### MEMORANDUM

RE: ZP 13-0991 SP

**Location:** 256-258 North Winooski Avenue and 260-262 North Winooski Avenue

**Request:** Combine 256-258 and 260-262 North Winooski Avenue; demolish all buildings, construct 2 new three story buildings with a total of 23 residential units and 1 commercial unit. Parking for all 24 units will be provided on-site. A shared access drive with Legal Aid is proposed.

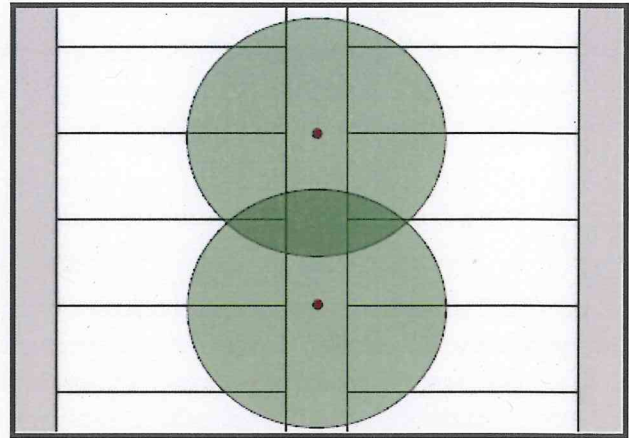
Direct pedestrian access is proposed from both the public sidewalk and the parking area on the east. There is no physical separation between pedestrian walk areas and the parking lot. A method of safe separation should be considered and developed. At Technical Review, a

1 handicap parking space is illustrated on the site plan. An accessible entry is recommended; a fully accessible unit is encouraged.

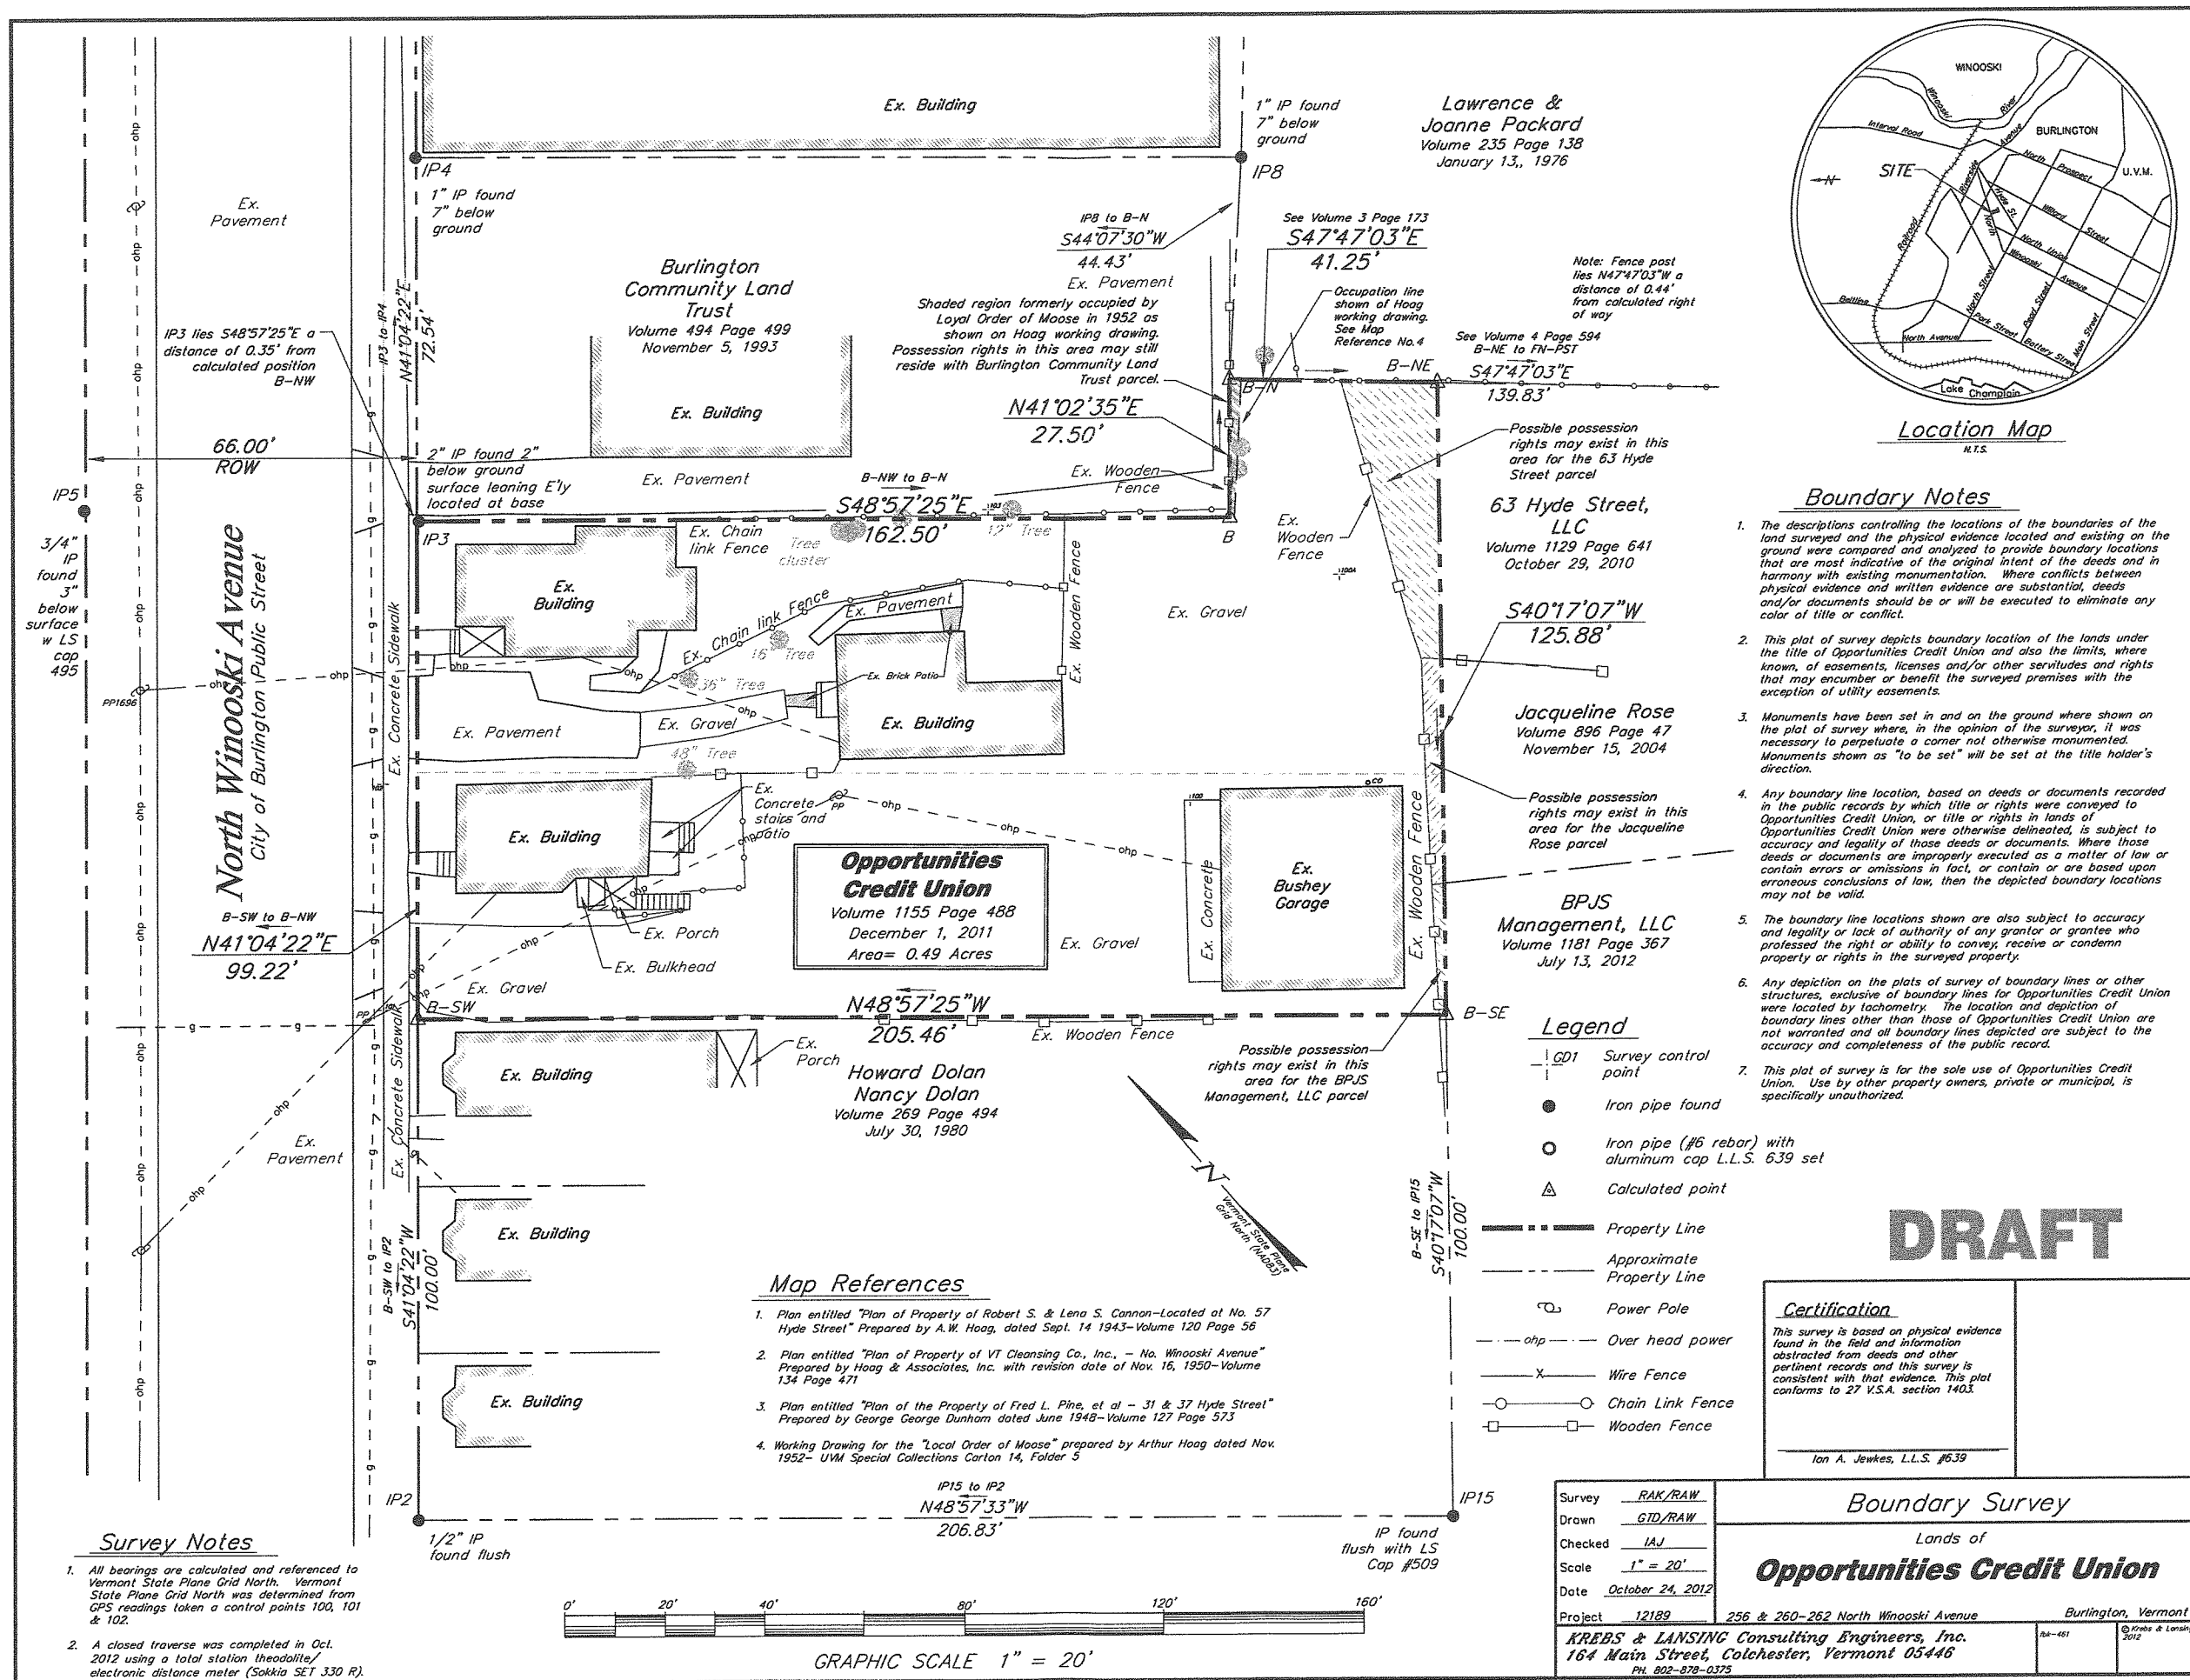
The applicant has made arrangements with the neighboring property owner (Legal Aid) for a shared access drive. This reduces the number of existing access points (driveways) from 3 to 1; and is a benefit to both property owners for comfortable entry and exit as well as providing spatial distance between structures.

The submitted site plan defines a 5' setback between the proposed parking area and the property lines. Barriers may be considered to prevent parking lot creep (although the pavement typically acts as definition for the termination of the parking area.) A hedgerow of landscaping or fencing may be an alternative, which would also address headlight creep into neighboring residential properties.

As the rear parking area may introduce beams from headlight onto the neighboring residential yards, landscaping or fencing along the rear boundary line should be considered.

The development includes a shared two-line access drive with the Legal Aid (264 North Winooski Avenue) parcel. Their parking will be immediately adjacent to this parcel in the side and rear; there is no change to their existing parking count.

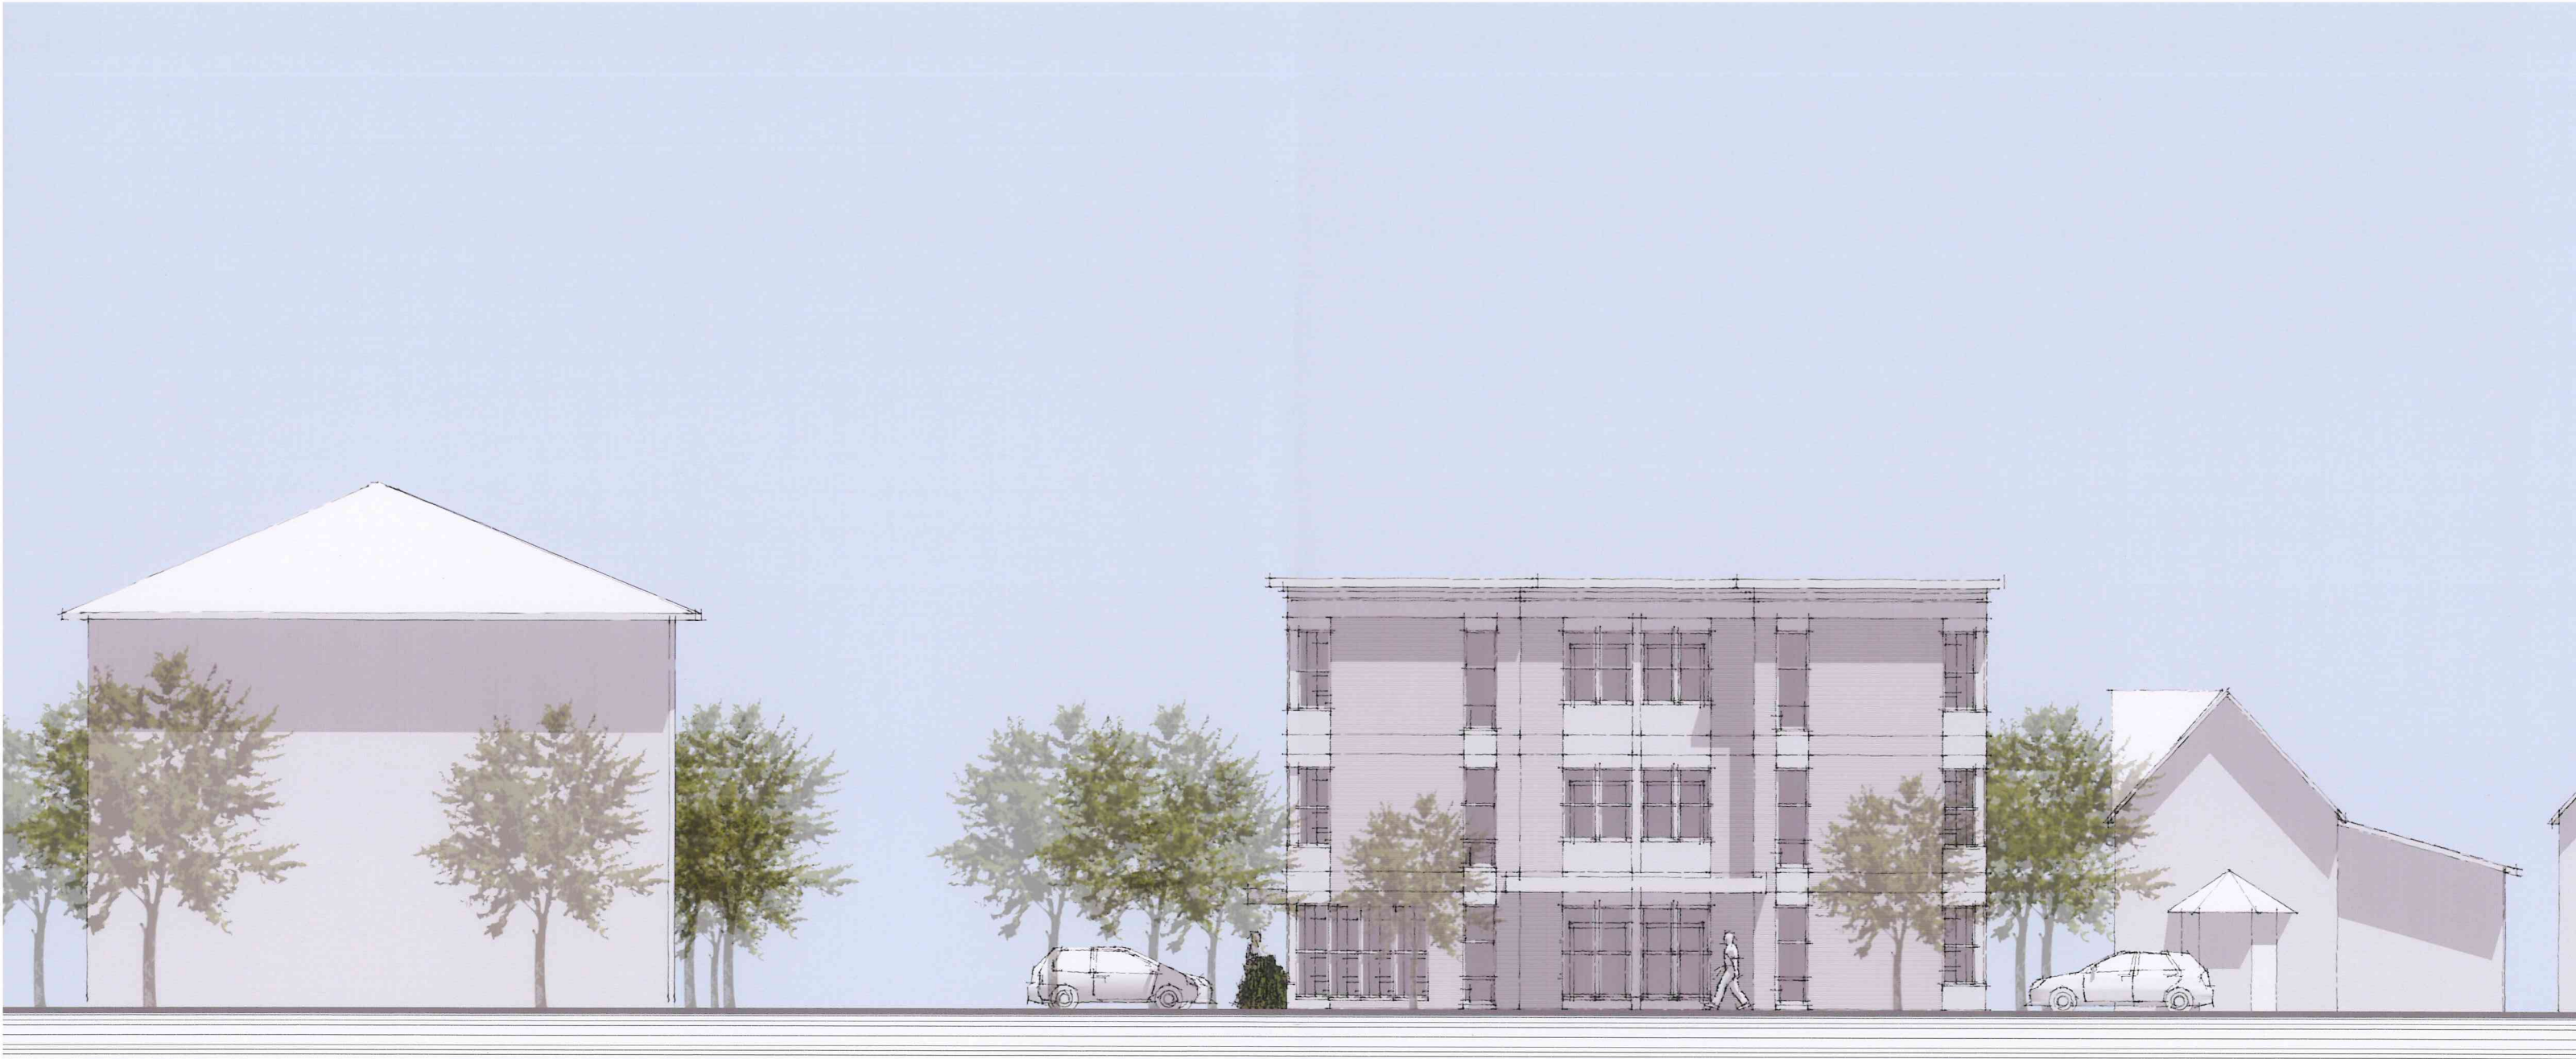
The buildings' design incorporated fluctuating wall planes, window arrangements, bays and projecting pavilions to keep the eye entertained and the building vibrant. The heavy cornice line "caps" the structures, yet directs the eye around the building for a fluid articulation of continued design. Materials are proposed to differ, with alternating expression around window bays and similar projections. Variations of metal sheathing are being considered.

While a flat roof is proposed, several neighborhood examples create an existing precedent for pattern. The roofline itself is animated, with expressive articulation along the cornice, and energized fluctuation reflecting façade plane changes. The result is dynamic and lively.

**SOUTH ELEVATIONS**  
3/32"=1'-0"

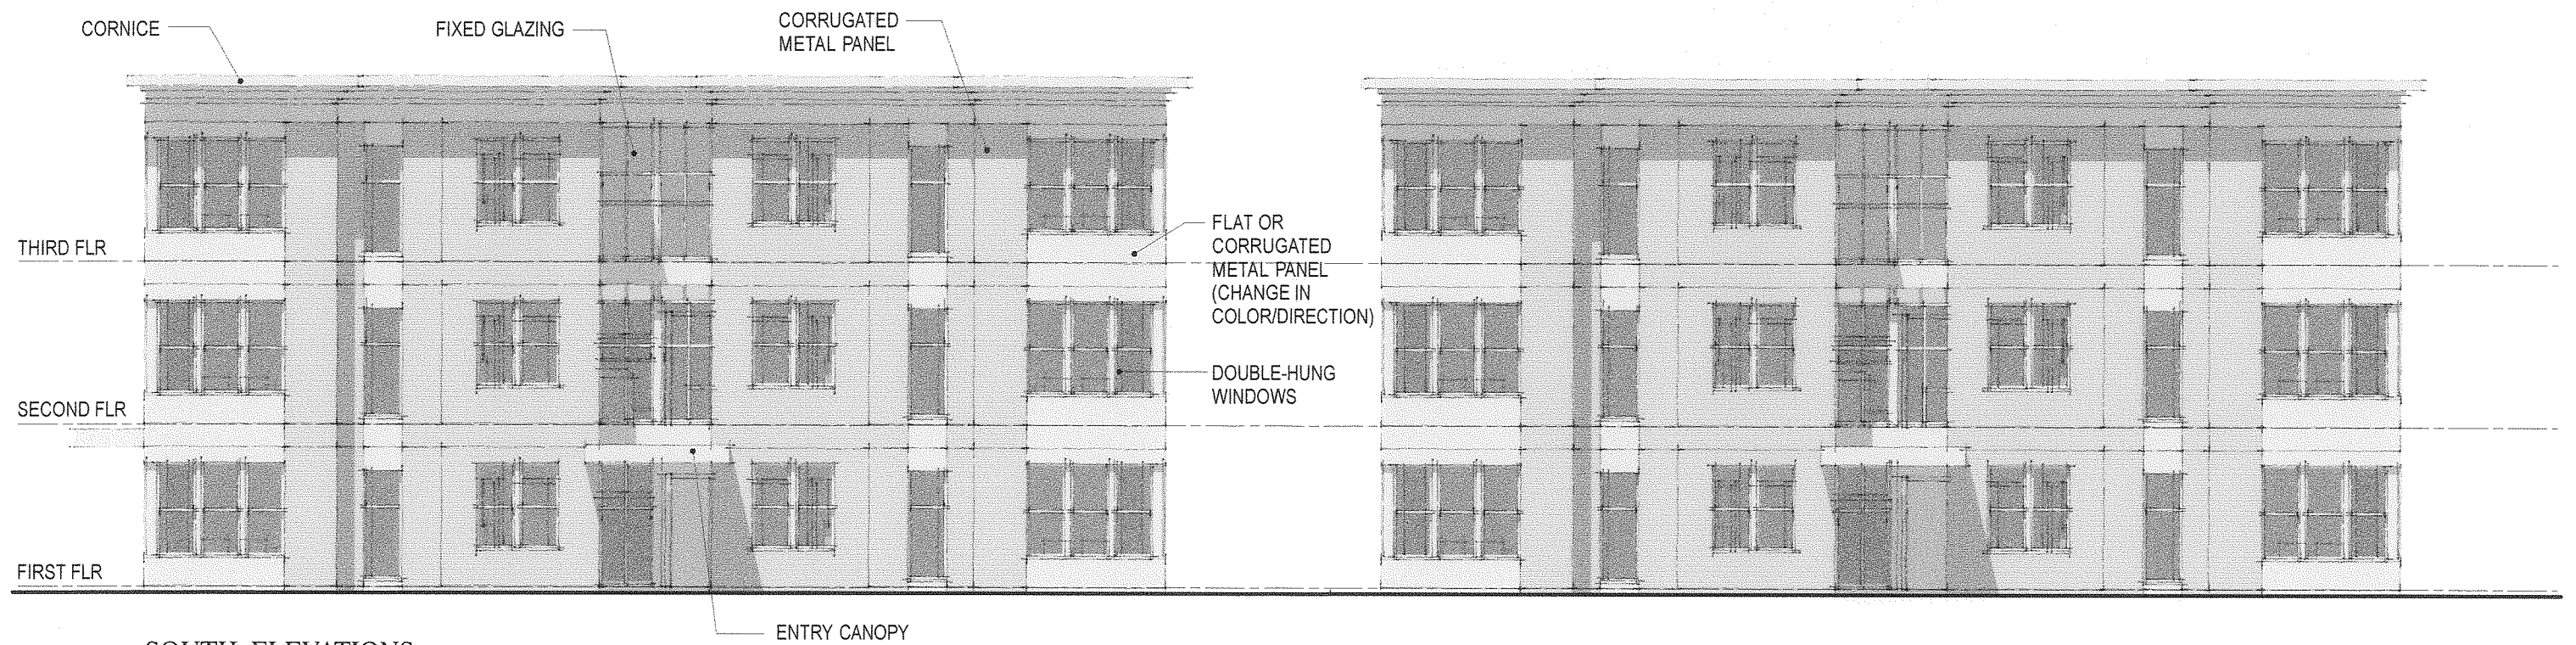
The proposed design incorporates variations along the street edge, including planar variation, material differentiation, trim/spandrel/cornice accentuation, and fenestration arrangement that activate and provide interest to the building.

Windows of residential units along the first floor that front North Winooski Avenue are minimal; however these may not have frosted glass or otherwise conflict from this standard. The minor setback from the sidewalk in this case may provide adequate measure of distance for privacy purposes.
